September 2021
Port of Stockton Rail Bridge Replacement and Rail Improvements Project

Final Initial Study/Mitigated Negative Declaration for the Port of Stockton Rail Bridge Replacement and Rail Improvements Project

State Clearinghouse No. 2021060578

Figure 5b
Proposed Rail Bridge Replacement
 Rail Bridge Replacement and Rail Improvements
 Port of Stockton, California

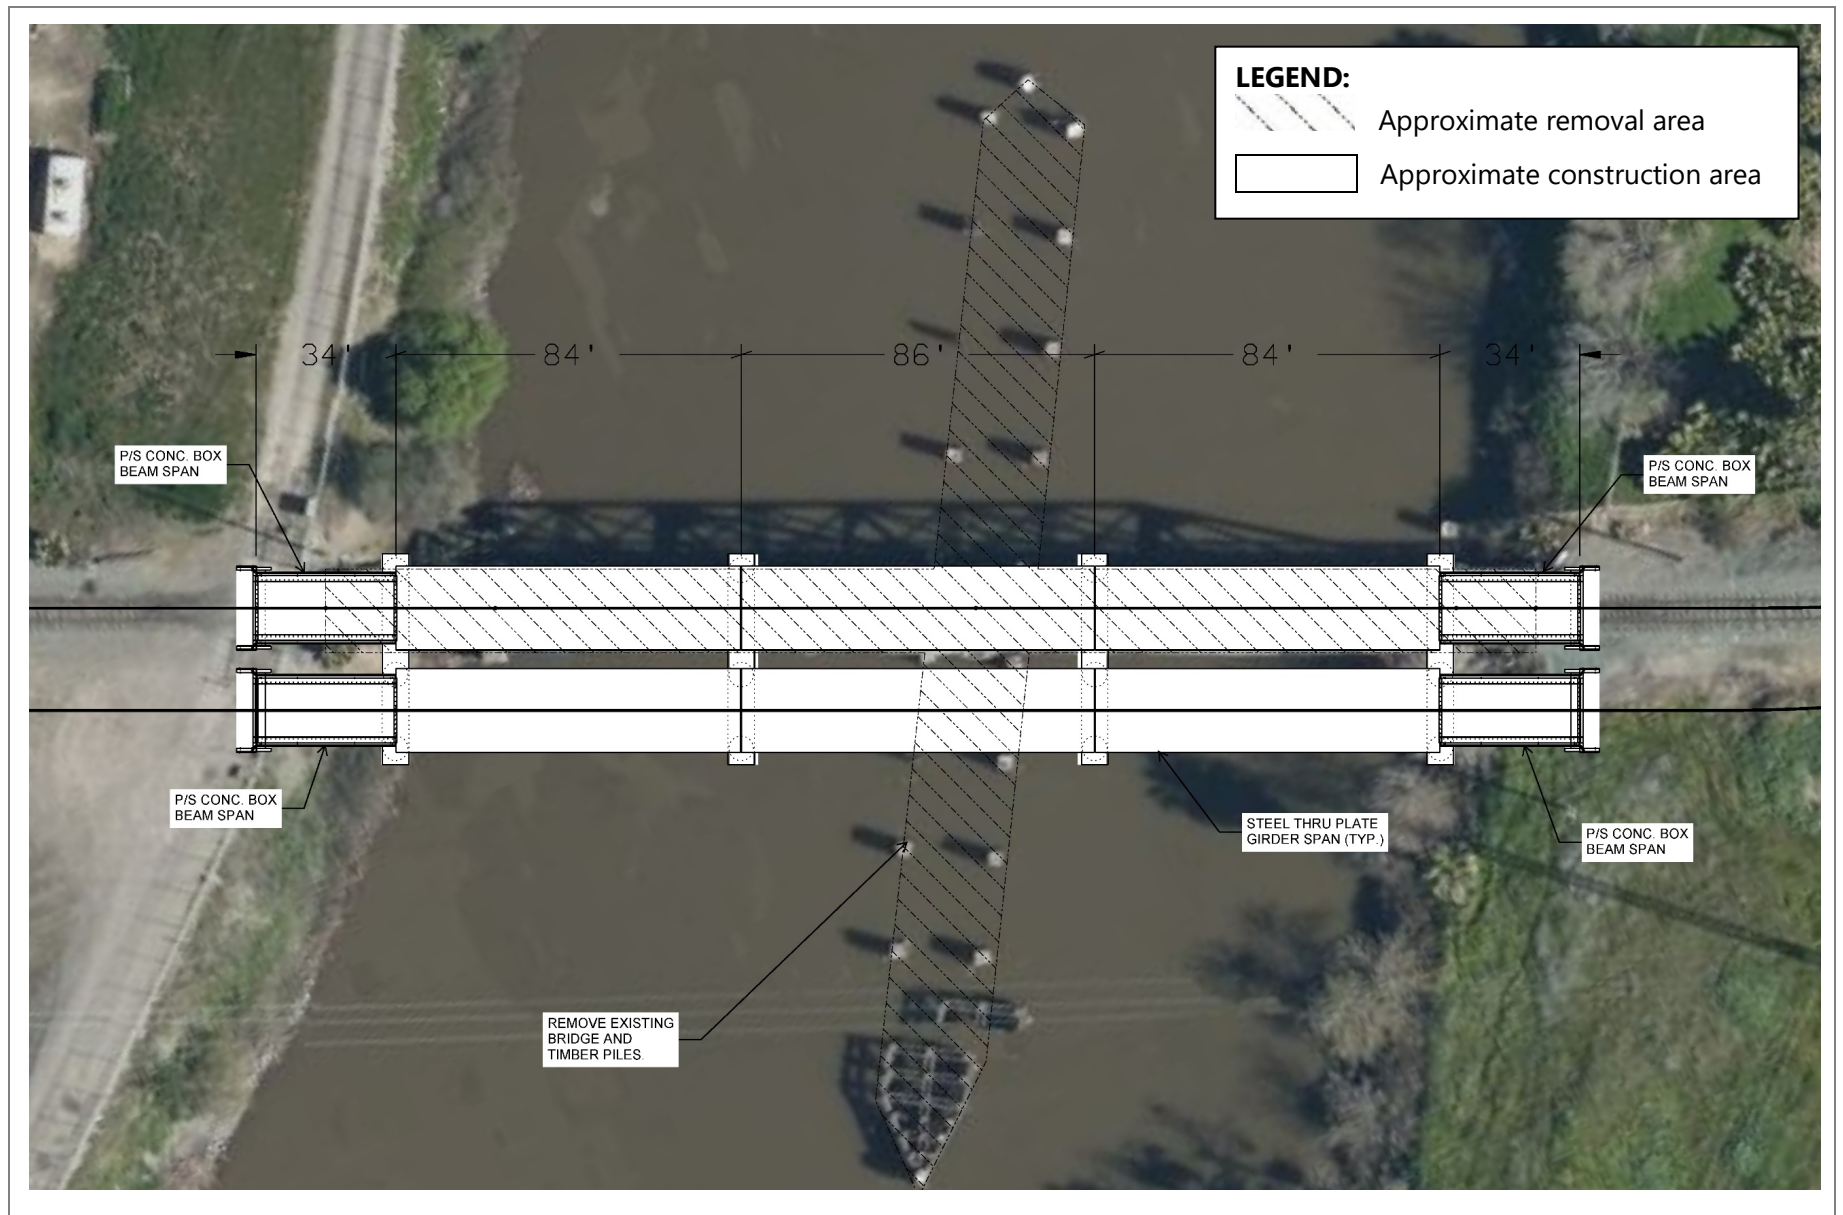
CSLC also requested revisions to Figure 5b. Per CSLC's request, the Port added a compass and legend to Figure 5b and included it in Section 3 (revisions to Section 2.4 of the Draft IS/MND). CSLC also requested that the mean high tide line be added to Figure 5b; however, the background in Figure 5b is an aerial photograph and the water elevation at the time the aerial photograph was taken is unknown, so the mean high tide line cannot be accurately added. Regardless, removal of the existing bridge and installation of the new bridge will include work in the San Joaquin River that is certainly below the mean high tide line. Preliminary plan sheets are provided in Appendix B, depicting the general arrangement of the conceptual design and preliminary estimated water elevation information. The channel bathymetry and water elevations will be confirmed in future project design stages. The Port will provide detailed plans showing the requested water elevation information as part of the CSLC lease application.

- a. Figure 5b (MND page 18): Please add a compass, legend, and mean high-tide line on the right and left banks of the River to help staff confirm that the analysis in the MND is adequate for possible environmental impacts on land under the Commission's jurisdiction.

The bridge replacement and rail improvements, and associated modifications, are shown in Figures 4 through 6 (updated Figure 5b) and Appendix B.
